## ADDENDUM #2

Lake Minneola Shores (CR 561) and Villa City Road (CR 565)  
Bridge Abutment and Pile Repair  
Project No. 2013-04  
Bid No. 13-0033

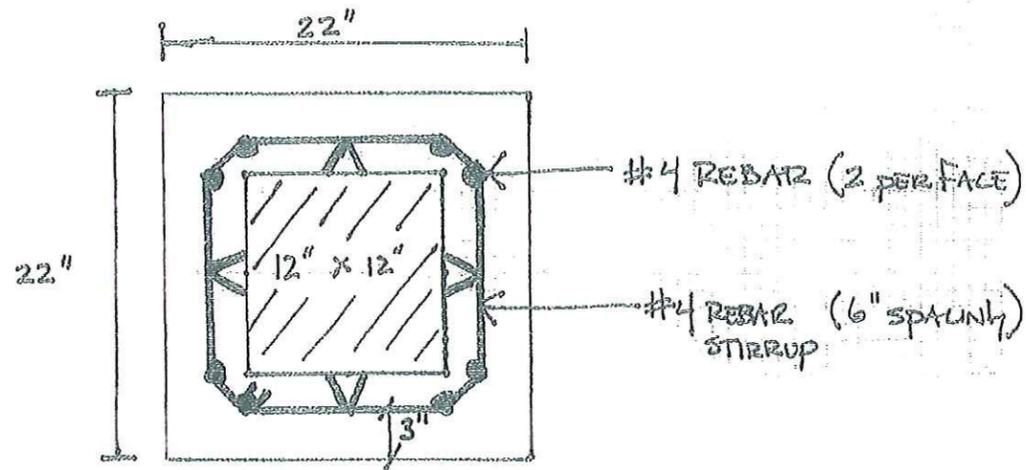
**Question: I cannot determine the limits of where the soldier pile is supposed to start and stop. Can you clarify this, or send a revised sketch?**

**Answer:** Please see attached detail.
